# **ENGINEERING ALTERNATIVES REPORT**

**West Bank and Vicinity, New Orleans, Louisiana  
Hurricane Protection Project  
Phase 2 Hurricane Protection  
Algiers Canal (East)  
Hero Levee to Hwy. 23  
WBV – 49.2  
Plaquemines Parish, Louisiana**

**October 30, 2008**

**FINAL**

SHEET IDENTIFICATION  
 C-109 A3

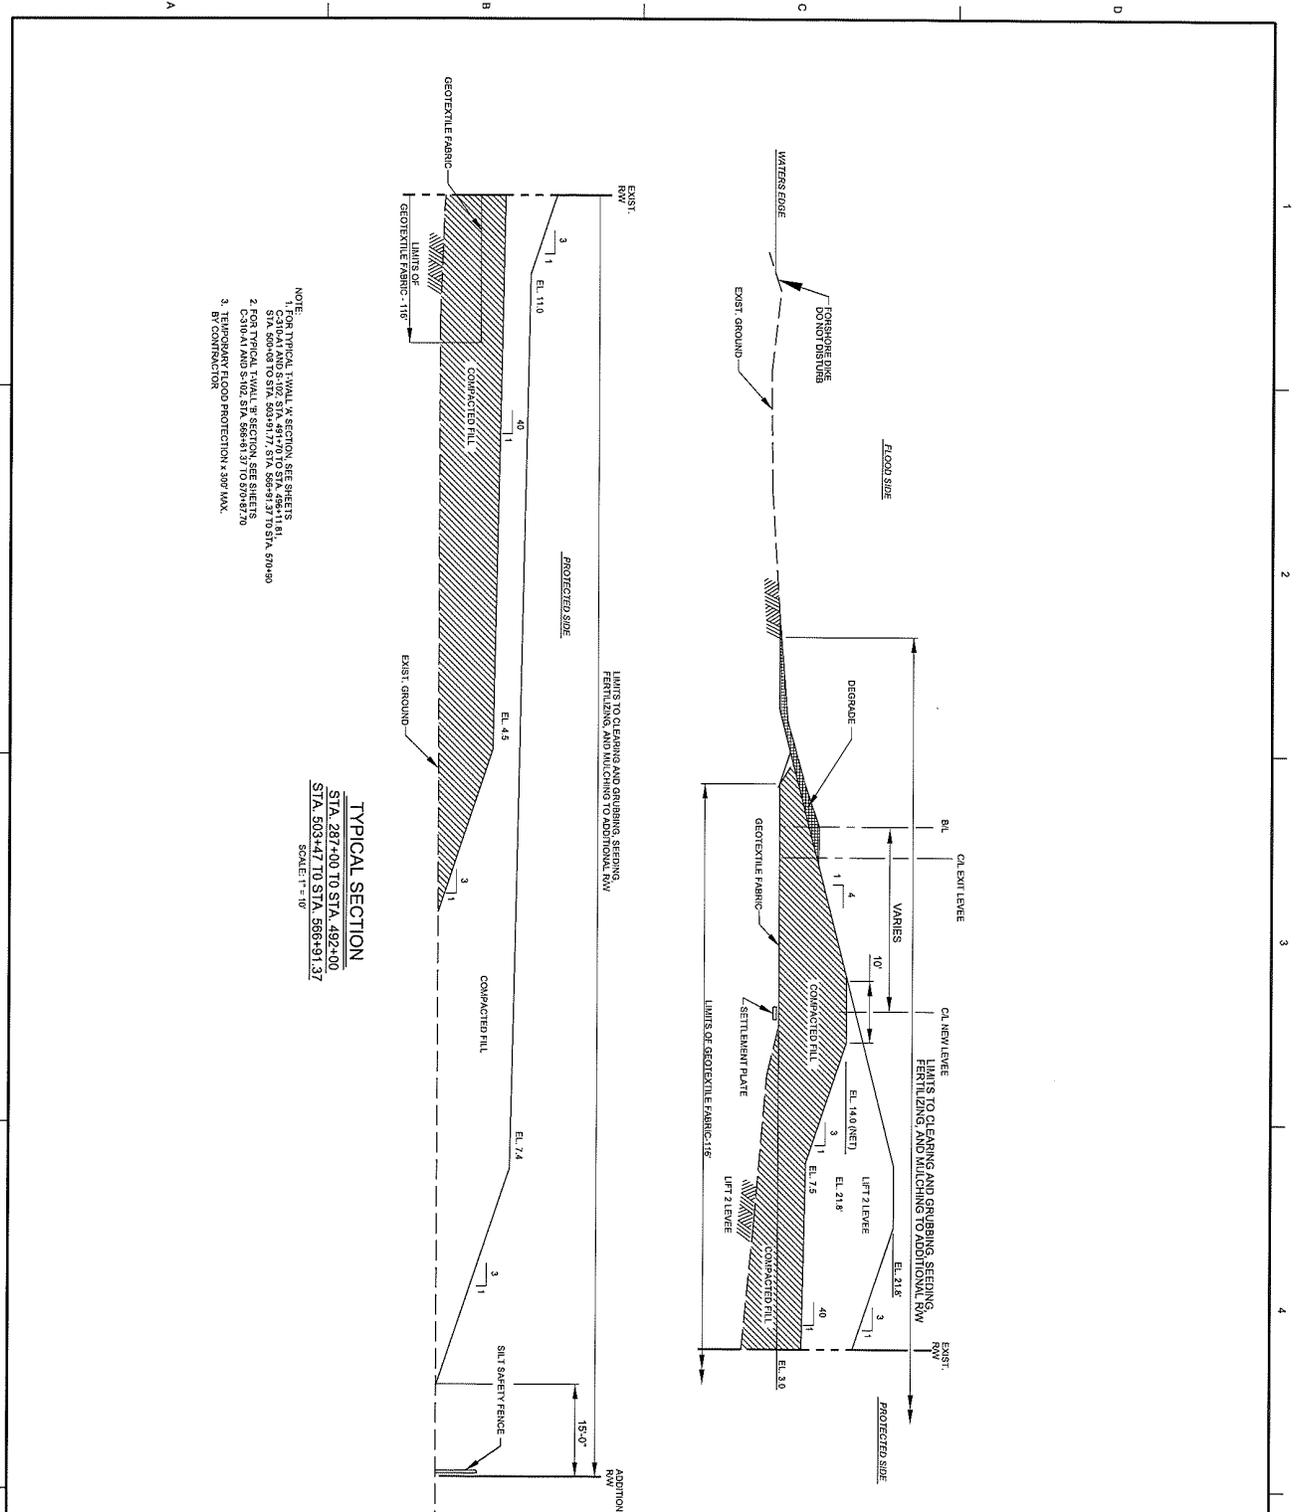
Submitted By: <u>Scott Chehardy</u> (504-466-5667) Submitted On: 01-Aug-08					
Current Comment Status: Comment Closed					
2029736	Civil	Feasibility Study	n/a'	Sheet G-103 A	n/a
Disposition table – This appears to be the same table copied from the T-wall option with the same dispositions. On this earthen levee alternative, I do not believe utilities will be relocated through "wall sleeves in sheet pile" as it states.					
Submitted By: <u>Scott Chehardy</u> (504-466-5667). Submitted On: 01-Aug-08					
1-0	<b>Evaluation Concurred</b> This will be corrected.  Submitted By: <u>Eugene Brian</u> (504-887-7045) Submitted On: 01-Aug-08				
1-1	<b>Backcheck Recommendation Close Comment</b> Closed without comment.  Submitted By: <u>Scott Chehardy</u> (504-466-5667) Submitted On: 01-Aug-08				
Current Comment Status: Comment Closed					
2029739	Civil	Feasibility Study	n/a'	Sheets C-101 A3 thru C-106 A3	n/a

1-0	<b>Evaluation Concurred</b> a. This will be corrected.  Submitted By: <u>Eugene Brian</u> (504-887-7045) Submitted On: 01-Aug-08				
1-1	<b>Backcheck Recommendation Close Comment</b> Closed without comment.  Submitted By: <u>Scott Chehardy</u> (504-466-5667) Submitted On: 01-Aug-08				
Current Comment Status: Comment Closed					
2029792	Civil	Feasibility Study	n/a'	Sheet C-310 A3	n/a
Quad D3 and D4 have text errors. "Exit Levee" should be "Exist Levee" and "Mulchint" should be "Mulching". The overlapping of the 2nd lift with the 2057 final levee section makes this drawing very confusing. Was there no levee

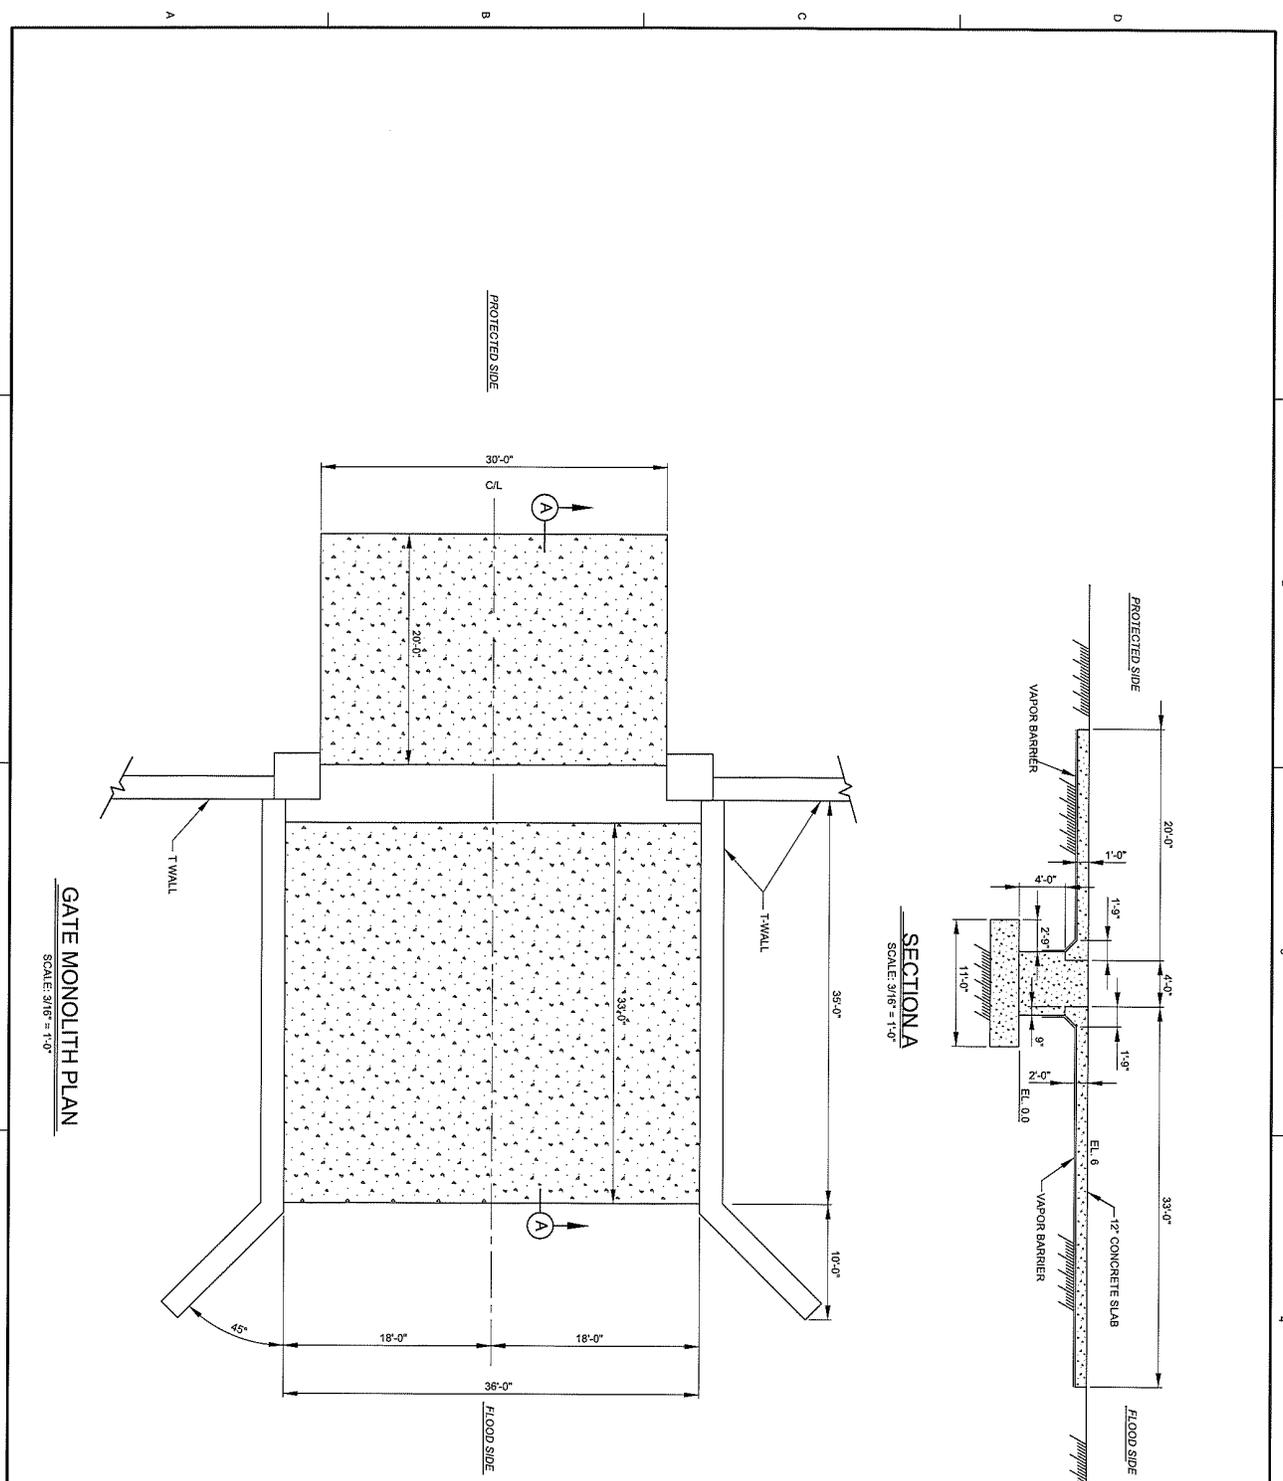
T-Wall B and T-Wall A shown on sheets S-101 and S-102 do not correlate with the typical section T-Wall B and T-Wall A on sheet C-310 A1. Please refer to previous comment on this. Sheet project title in title block on these two sheets is shifted out of the title block.

1916358	Geotechnical	n/a'	EAR, Plate S-102, Section A Detail	n/a
On this section, the flood side base is 6'-0" and the protected side base is 2'-0" with a 2'-0" stem width for the Type A T-Wall. However, plates C-310-A1 through C-312-A1 have 5'-6" and 2'-6", respectively, with a 2'-0" stem width for the same Type A T-Wall.				
Submitted By: Leeland Richard (504-862-2397). Submitted On: 19-May-08				
1-0	<b>Evaluation Concurred</b> The drawing dimensions will be coordinated.			
Submitted By: Jens Nielsen (504 887 7045) Submitted On: 29-May-08				
1-1	<b>Backcheck Recommendation Close Comment</b> Closed without comment.			
Submitted By: Leeland Richard (504-862-2397) Submitted On: 10-Jun-08				
Current Comment Status: Comment Closed				
1916359	Geotechnical	n/a'	EAR, Structural Calculations, T-Wall Type A, Pgs 4 & 5 of 36	n/a
Please explain why the pile capacity curves do not increase with depth at a greater rate than is shown here starting at a depth of approximately 82 feet.

Current Comment Status: Comment Closed				
2050502	Structural	Appendix c	n/a	n/a
(Document Reference: Concrete Structures)				
<p>Plate S-102 does not match the diagram of the pile layout or the CPGA input.</p> <p>Submitted By: <a href="#">Ira Dorsett (504-862-1116)</a>. Submitted On: 14-Aug-08</p>				
1-0	<p><b>Evaluation Concurred</b>                  Plate S-102 will be corrected to match calculations.</p> <p>Submitted By: <a href="#">Eugene Brian (504-887-7045)</a> Submitted On: 22-Aug-08</p>			
1-1	<p><b>Backcheck Recommendation Close Comment</b>                  Closed without comment.</p> <p>Submitted By: <a href="#">Ira Dorsett (504-862-1116)</a> Submitted On: 16-Sep-08</p>			
Current Comment Status: Comment Closed				
2055014	Structural	n/a'	S-103	n/a
<p>It is not clear why the retaining wall system is still used for the gates. Why not taper this fill back to EI 9.5 as required to allow a normal gate crossing. The area without the F/S berm can be designed for barge impact. From S-104, it is not clear how the gate is opened/closed with a retaining wall in the way.</p> <p>Submitted By: <a href="#">David Lovett (504-862-2680)</a>. Submitted On: 18-Aug-08</p>

1-0	<p><b>Evaluation Concurred</b> These details are correct as shown. The titles on sheet C-310 A1 will be switched to their correct position.</p> <p>Submitted By: <u>Eugene Brian (504-887-7045)</u> Submitted On: 01-Aug-08</p>
-----	---

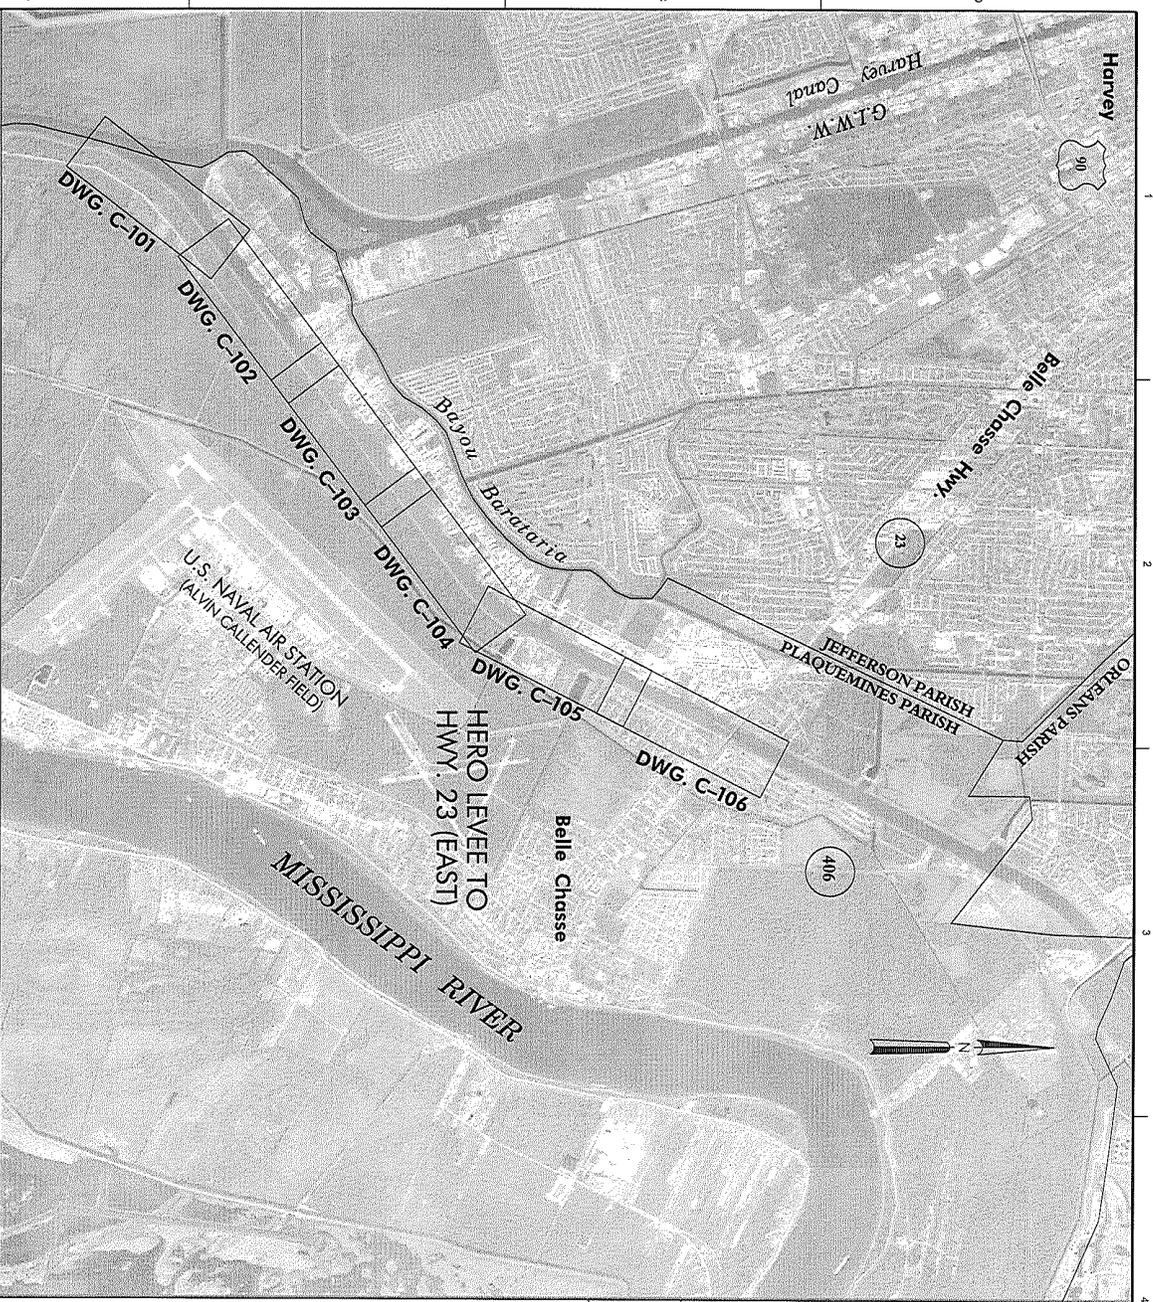
Current Comment Status: Comment Closed					
2030857	Structural	Technical Report	n/a'	n/a	n/a
On Dwg. S-105, the gate diagonals should probably be tie rods, in lieu of the channels shown. Suggest changing if project moves forward.  Submitted By: <u>Robert Yokum</u> ((985) 674-1846). Submitted On: 01-Aug-08					
Revised 01-Aug-08.					
1-0	<b>Evaluation Concurred</b> See response to Comment No. 2030840.  Submitted By: <u>Eugene Brian</u> (504-887-7045) Submitted On: 04-Aug-08				
1-1	<b>Backcheck Recommendation Close Comment</b> Closed without comment.  Submitted By: <u>Robert Yokum</u> ((985) 674-1846) Submitted On: 04-Aug-08				
Current Comment Status: Comment Closed					
2030860	Structural	Technical Report	n/a'	n/a	n/a
On Dwg. S-106 the foundation plan for the gate doesn't appear to be as robust as expected. With only two rows of piles, there is little to no redundancy or excess stiffness. This is further compounded by having only 1 row of battered piles. If the project advances to a detailed level, I suggest, that the batters be increased from 1:6 to 1:3 to add overall foundation stiffness.  Submitted By: <u>Robert Yokum</u> ((985) 674-1846). Submitted On: 01-Aug-08

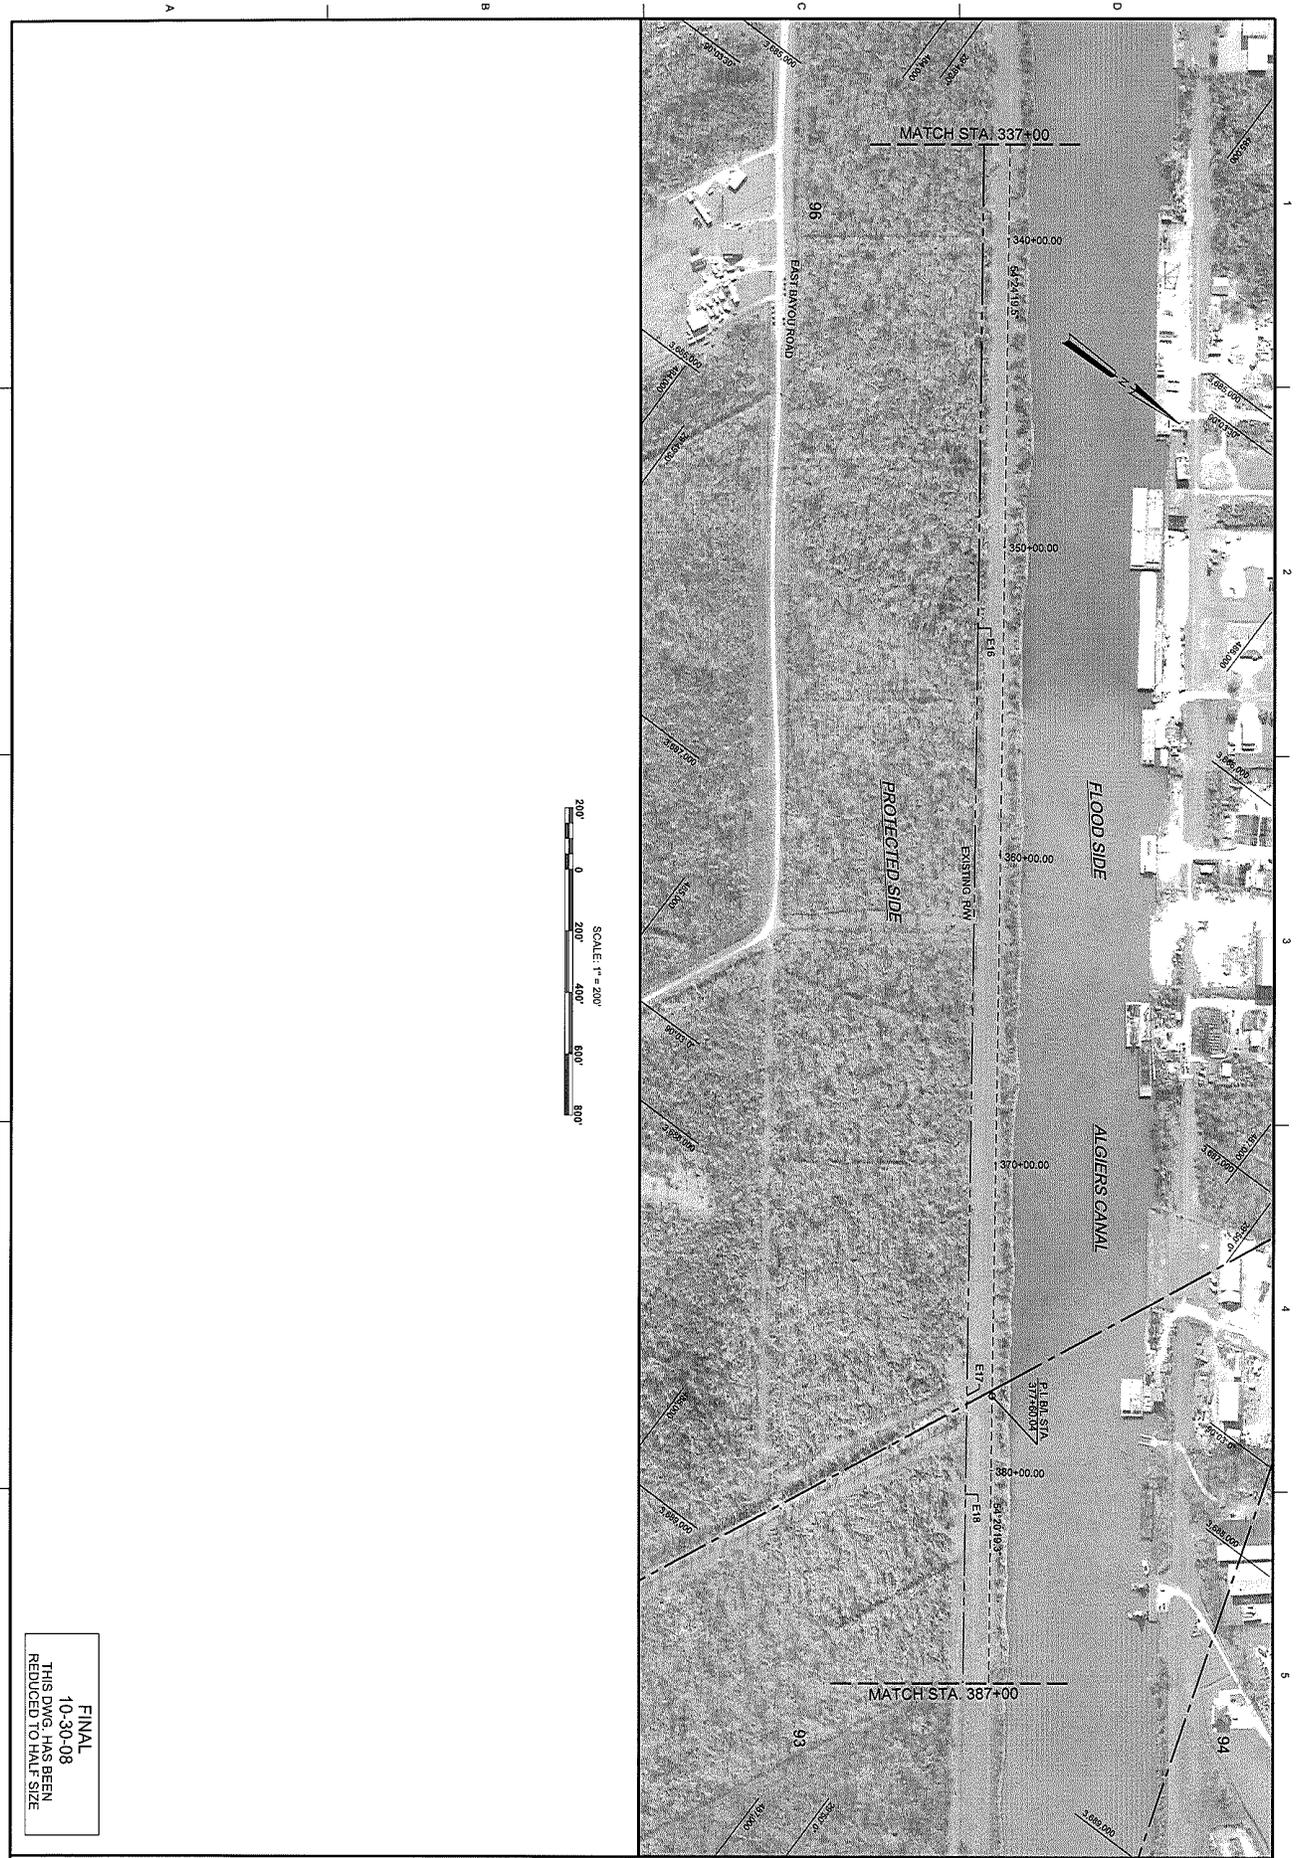
<p>Current Comment Status: <b>Comment Closed</b></p>					
2029689	Civil	Feasibility Study	n/a'	Sheets C-101 A1	n/a
<p>·Note should say G-102 A ·Transition from Type A to B is not shown in profile (similar to C-105 A1) ·Top of scour protection not shown here or in C-102 A1 but it is shown on sheets C-103 thru C-105. ·The legend shows a line type for the "Additional R/W" that does not match the one shown in the plan view.</p> <p>Submitted By: <a href="#">Scott Chehardy (504-466-5667)</a>. Submitted On: 01-Aug-08</p>					
1-0	<p><b>Evaluation Concurred</b>                      Drawing will be corrected.</p> <p>Submitted By: <a href="#">Eugene Brian (504-887-7045)</a> Submitted On: 01-Aug-08</p>				
1-1	<p><b>Backcheck Recommendation Close Comment</b>                      Closed without comment.</p> <p>Submitted By: <a href="#">Scott Chehardy (504-466-5667)</a> Submitted On: 01-Aug-08</p>				
<p>Current Comment Status: <b>Comment Closed</b></p>

disposition table utility numbers missing. There is possibly a layer turned off. -On sheet C-101 it states "Begin T-wall Construction". This is not correct.
